# Access Compliance Report

## Public Rights-of-Way

### (Curb Ramps)

Intersection ID: 43204	Main Street: PLANTAIN_CT	Cross Street: SPEEDWELL_CT	Location: SE
ADA ID: 8DA909EDFA20	Ramp Type: PerpDiag	Initial Pass/Fail: Fail	Overall Compliance: No
Severity Score: 22.5			
Codes/Mitigation Info/Possible Solution		Field Measurements/Component Compliance

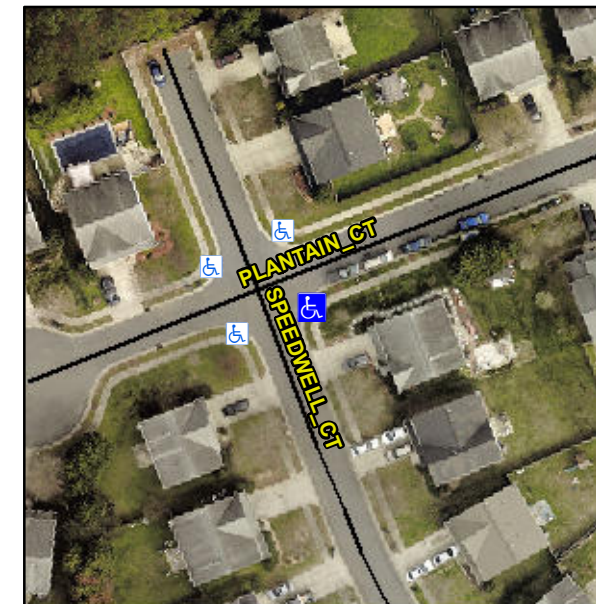
**Not Found, R304.5.1, R304.2.2, R304.5.3**

Compliance	Description	Data	Compliance	Description	Data
N/A	Ramp Length (in)	49.0	No	Ramp Slope (%)	10.2
No	Ramp Width (in)	37.0	No	Ramp XSlope (%)	3.5
N/A	Flare Type LT	N/A	N/A	Flare Type RT	N/A
N/A	Flare Slope LT (%)	N/A	N/A	Flare Slope RT (%)	N/A
N/A	Flare Traversable LT?	N/A	N/A	Flare Traversable RT?	N/A
N/A	Landing Length (in)	N/A	N/A	DWS Provided?	N/A
N/A	Landing Width (in)	N/A	N/A	DWS Contrast?	N/A
N/A	Landing Slope (%)	N/A	N/A	DWS Length (in)	N/A
N/A	Landing X Slope (%)	N/A	N/A	DWS Full Width?	N/A
N/A	Landing Curb? (Y/N)	N/A	N/A	DWS Offset (in)	N/A
N/A	Shared Landing?	N/A			
N/A	Gutter Ponding?	N/A	N/A	Gutter Slope (%)	N/A
N/A	Gutter Lip Ht (in)	N/A	N/A	Gutter X Slope (%)	N/A
N/A	Painted X Walk1?	No	N/A	Painted X Walk2?	No
	X Walk 1 Direction	To N		X Walk 2 Direction	To W
N/A	X Walk 1 Width (in)	N/A	N/A	X Walk 2 Width (in)	N/A
	X Walk 1 Slope (%)	6.5		X Walk 2 Slope (%)	2.1
	X Walk 1 X Slope (%)	2.8		X Walk 2 X Slope (%)	2.4

**Remove & Replace Curb Ramp With Two New Directional Ramps or Equivalent.**
